## REVISIONS TO THE RED HILL GROUNDWATER PROTECTION PLAN

**Date:** December 2009

**Document Title:** Red Hill Bulk Fuel Storage Facility Final Groundwater Protection Plan, Pearl Harbor, Hawaii of January 2008

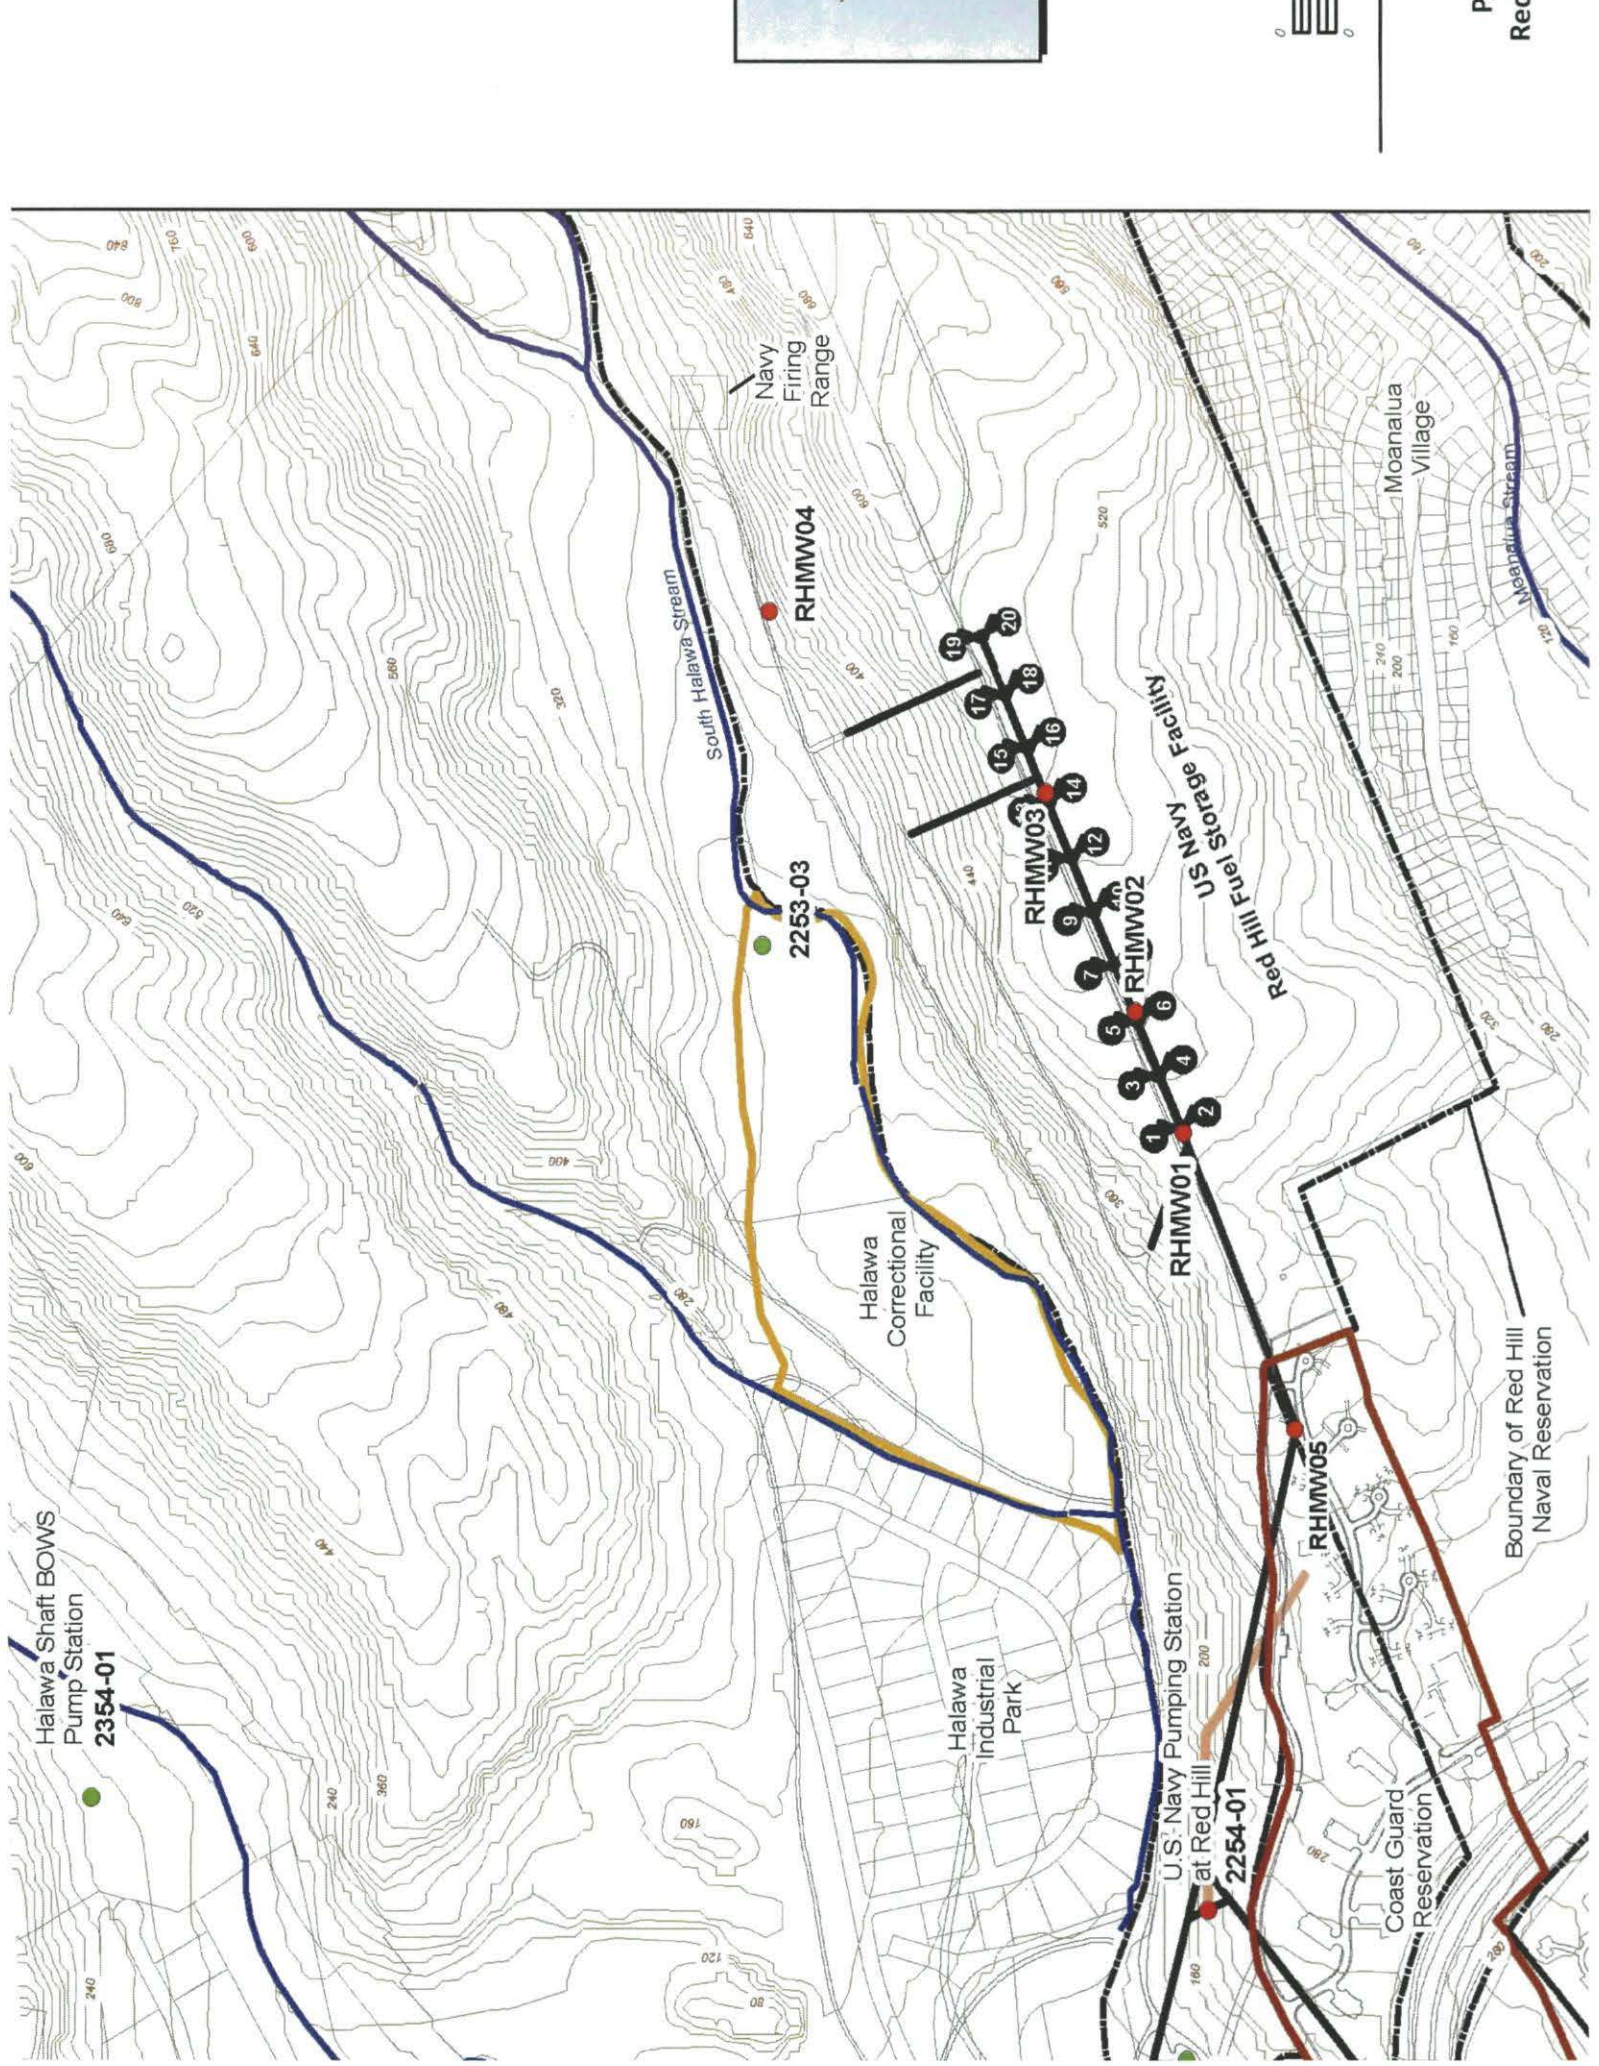
3.	1-14	Figure 1-4	Added the location of RHMW05	An additional groundwater monitoring well, RHMW05, was installed between RHMW01 and US Navy Well 2254-01 in July 2009.
